Interoffice Memorandum

June 20, 2016

From: Leigh Simmons
To: Mike Boulay

**Subject: King Coal Mine (Permit No. C-1981-035)
Hay Gulch water monitoring review**

Figure 2: King I Mine facilities bench, with Hay Gulch and the refuse pile

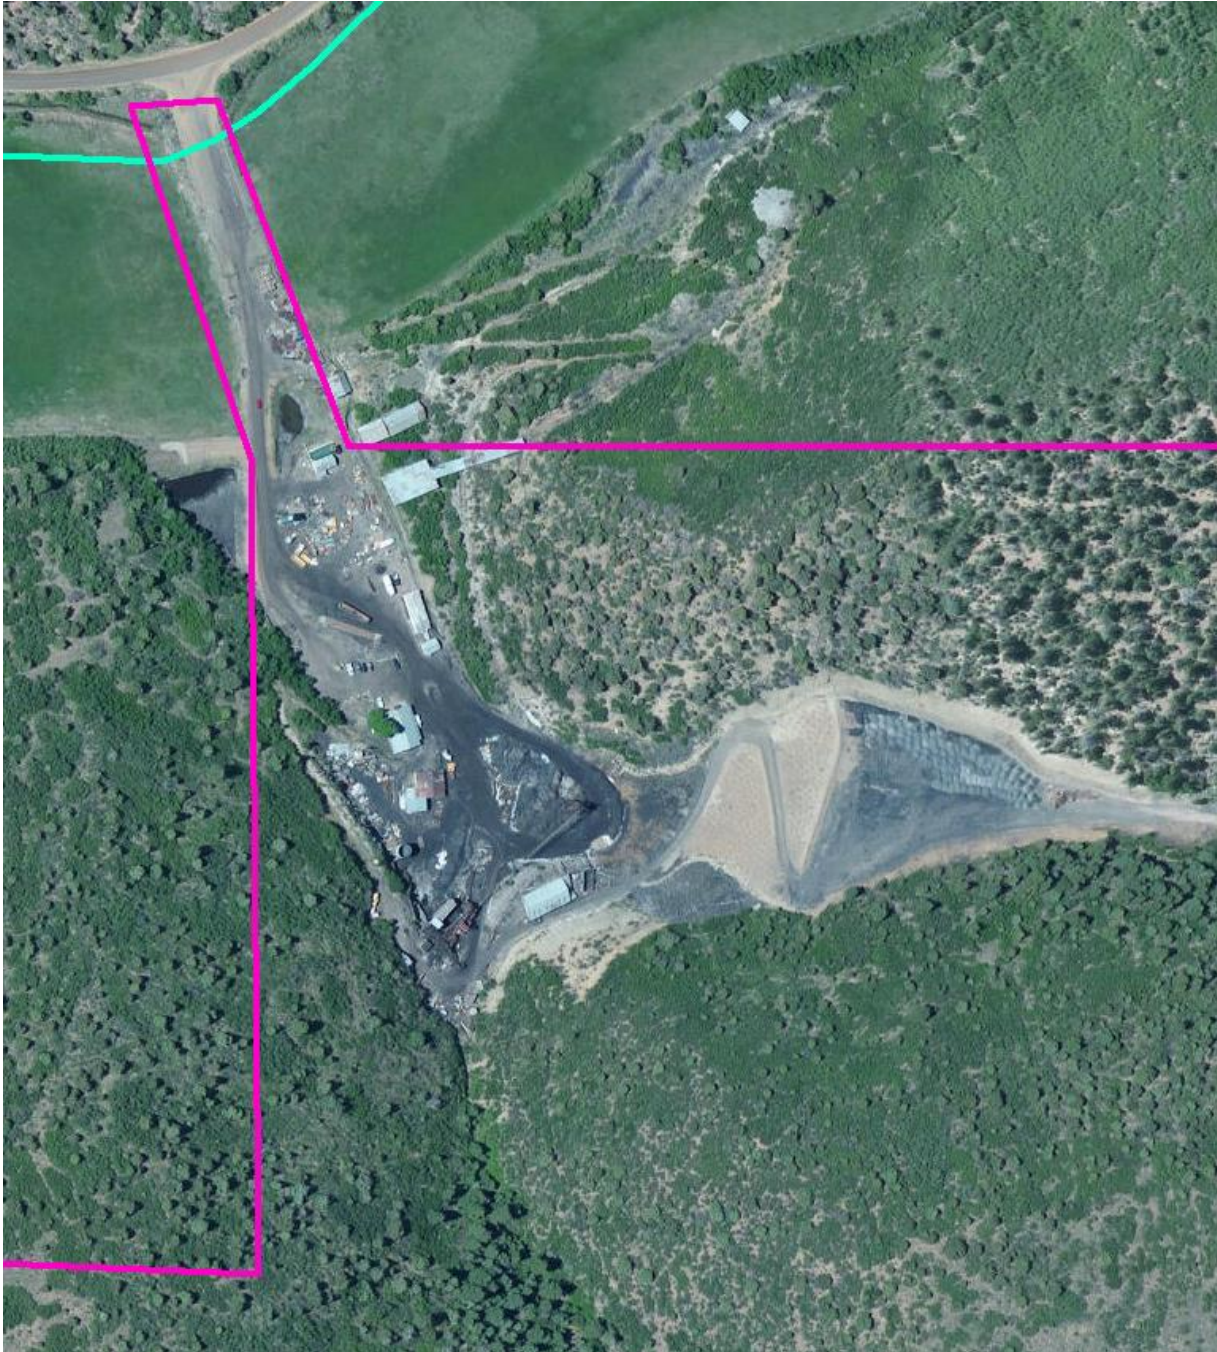
Map King I-007, Operation Plan & Surface Features, shows the disturbed area boundary, but not the permit boundary, to a high level of detail around the King I facilities area. Other maps in the PAP which show the permit boundary (e.g. Map King I-001, Permit & Adjacent Areas) are drawn at a much larger scale, making small details difficult to see; nevertheless it appears as though the west sediment pond, which receives water draining from the refuse pile, is outside of the permit boundary, (see figure 2).

- a. Sections 2.04.5, 2.04.6, 2.04.7, 2.05.3 and 2.05.6 of the PAP should be completely revised and significantly expanded. If the multi-volume approach is retained the text in one volume should simply refer to the relevant section in the other volume where possible. Information in appendices should be summarized in the text, and explained where appropriate.
- b. The permit boundary should be verified and must include all mine related disturbance. Maps should be updated to include the permit boundary layer, in accordance with rule 2.10.1(3).
